ADDITION/RENOVATION OF
SINGLE FAMILY DWELLING

ADDITION, NEW ROOF, NEW SIDING & RENOVATIONS.

It is necessary for me to clarify and certify two (2) items, the first was a field change related to a window header and the other was a correction of the wind bracing notes on Sheet #3.

I have received your plan review comments with regard to the above referenced project and offer the following responses:

WALSH RESIDENCE
 Block 953 LOT 18
 111 LADDER FIELD A/C.
 TOTAL PIPE 40'
 TOTAL BTU 245,000
 CURRENT FUTURE 38'

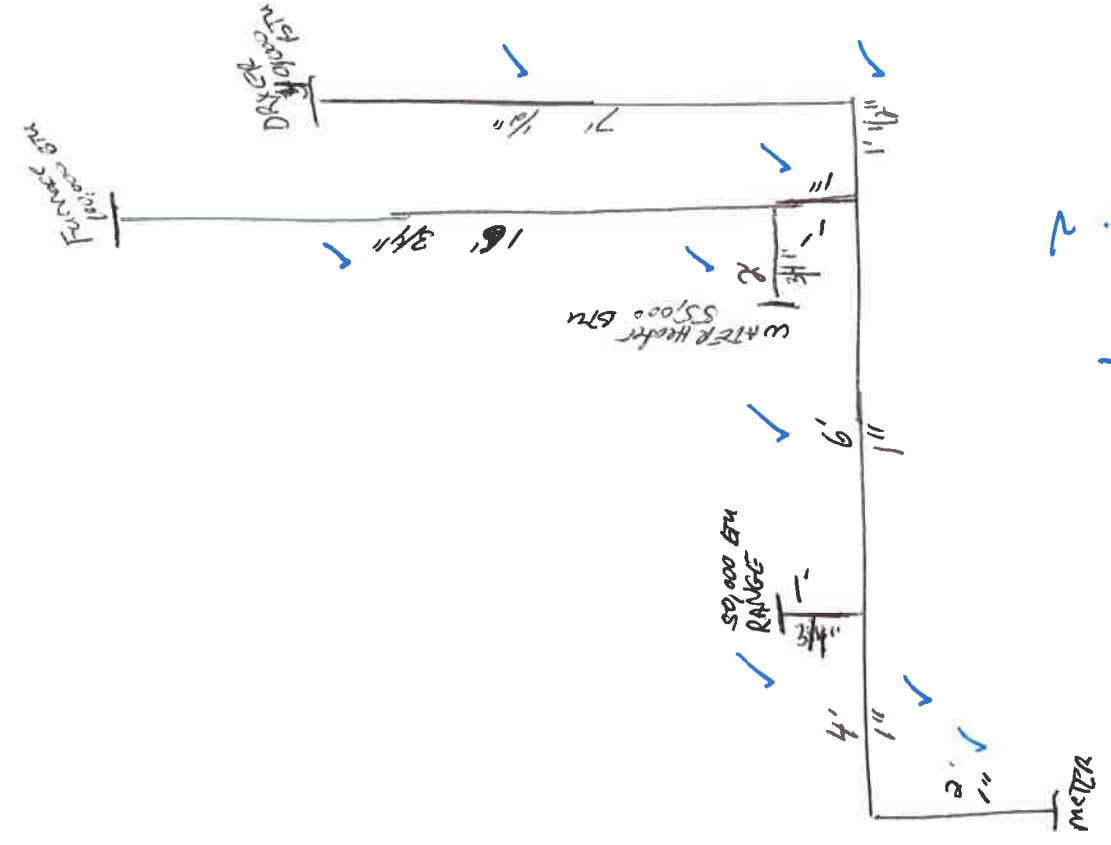
30' TDL
 2
 O.K. BUT CHECK DISTANCE! EXIST. EQ. . .
 12-29-8
 HAWG

FOOTING, POST, GIRT CONNECTION

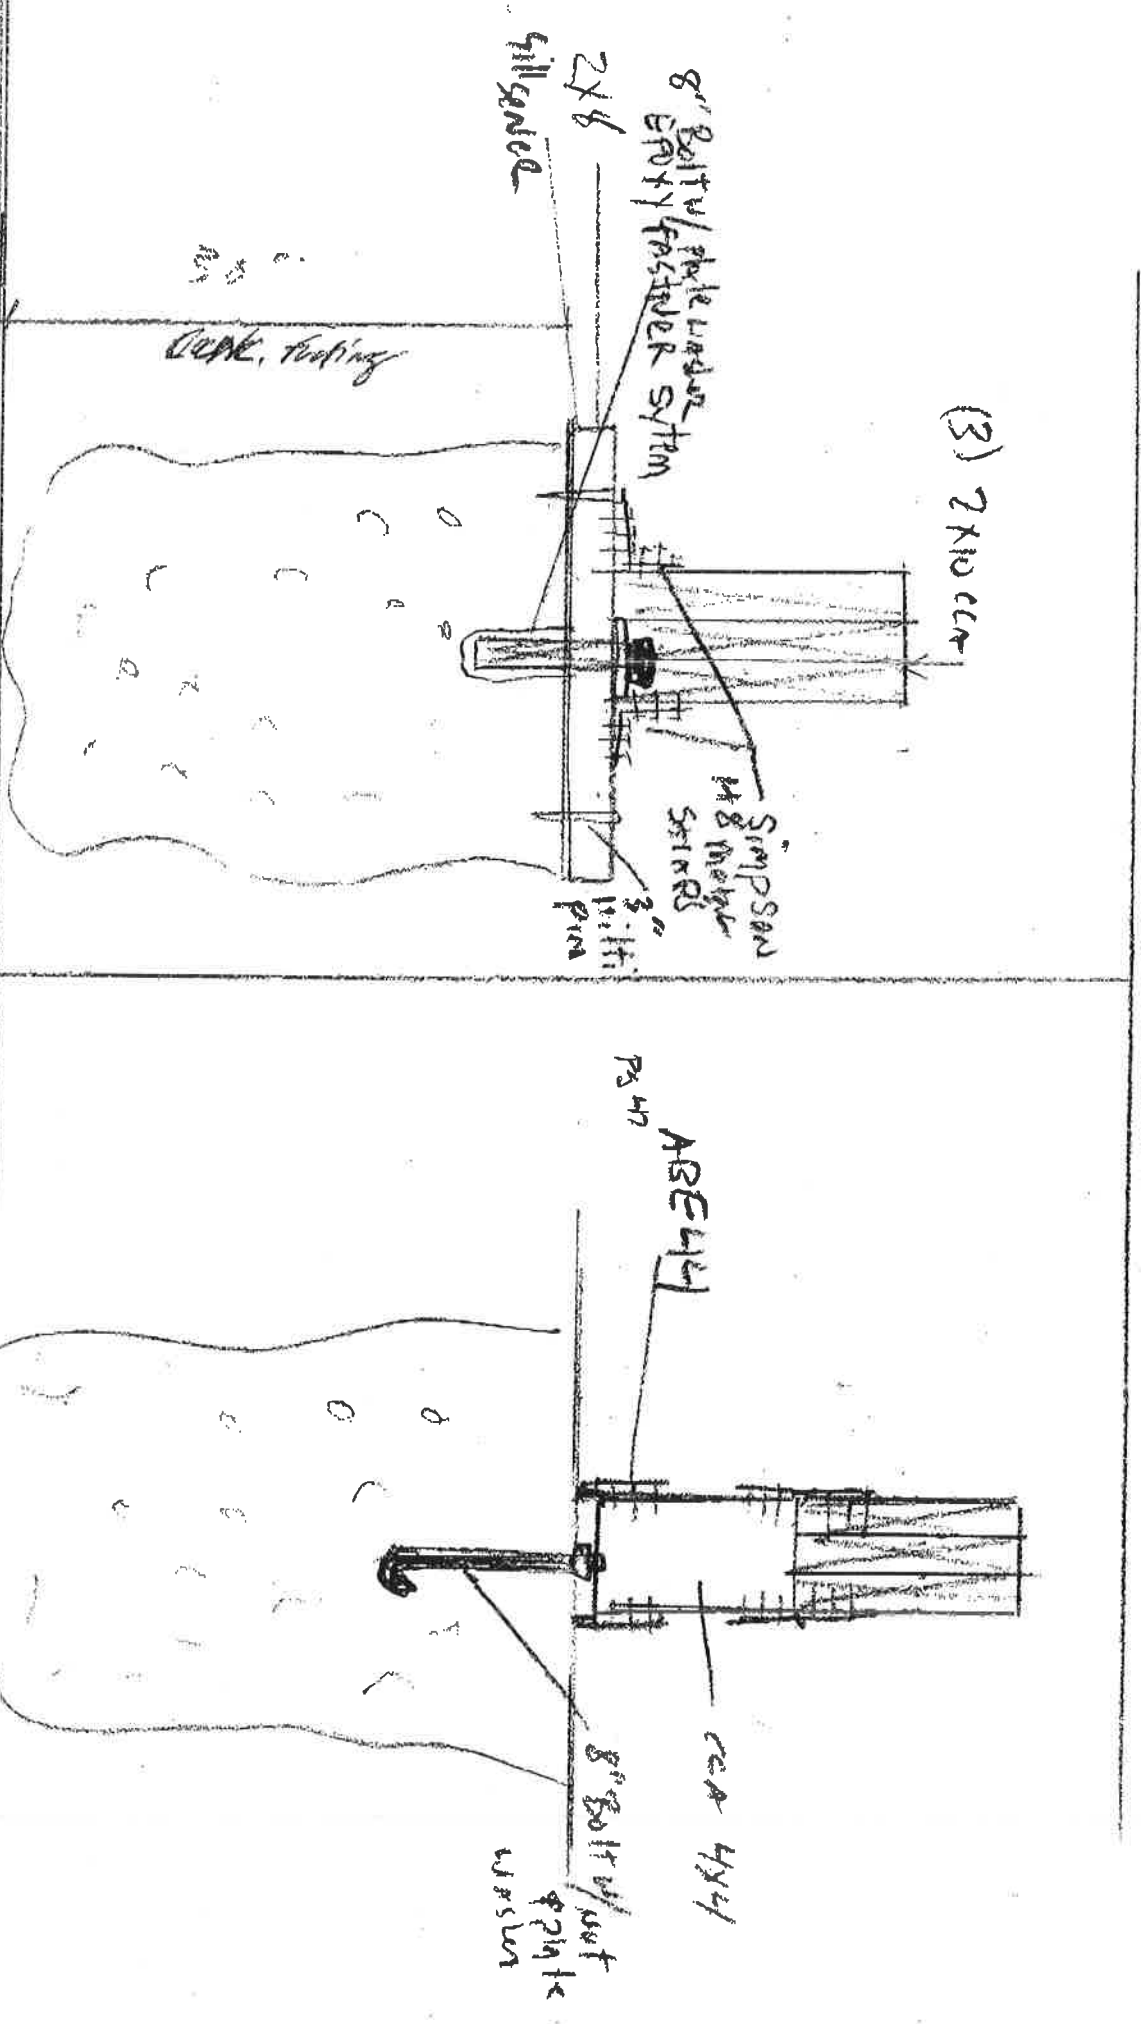
Note * Bob, 150 put strips every 3rd.

1. **STRAPS** - rather than precut 36" long straps on every third stud, roll strapping was used, cut to 24" lengths and installed at each stud. The material used is also a Simpson product of the same gauge as the precut straps. I do concur with the Inspector's instructions to remove and replace the 24" straps on every third stud with 36" long straps.
2. **SECURING DECK TO PIERS** - due to the varying height of the tops of the piers, it was necessary to eliminate the 4 x 4 posts in most instances. The method indicated on the Contractor's sketch (copy attached) is acceptable. The use of a Simpson epoxy grout system to secure the wolmanized 2 x 8 to the concrete pier provides the resistance to uplift required. The (3) 2 x 10 girders supporting the deck are secured with Simpson M8 straps, this provides an adequate connection.
